**PRODUCT INFORMATION BULLETIN**

**SUBJECT:** Dunkirk Quantum 90 Boiler

Dunkirk Boilers is pleased to announce two improvements to the Q90 series boilers:

**HOT SURFACE IGNITER STYLES: (Old v. New)**

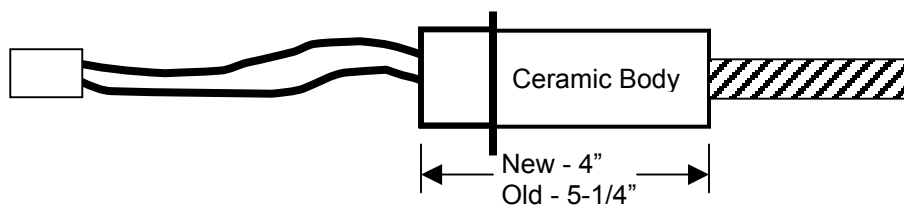
It has been determined that the shorter igniter used on the Q90-50 and 75, operates at lower temperatures during boiler main fire than did the longer Q90-100 igniter resulting in longer life. The shorter igniter, part number 43800013, is now being used in production of all Q90 boilers as well as for replacements of any age Q90 boiler currently installed in the field.

We are currently accepting warranty return of any of the long igniters (part no. 43800014) you may have in stock for exchange for shorter igniters. Please contact the Dunkirk Customer Service Department at 716-366-5500 to arrange for a warranty exchange.
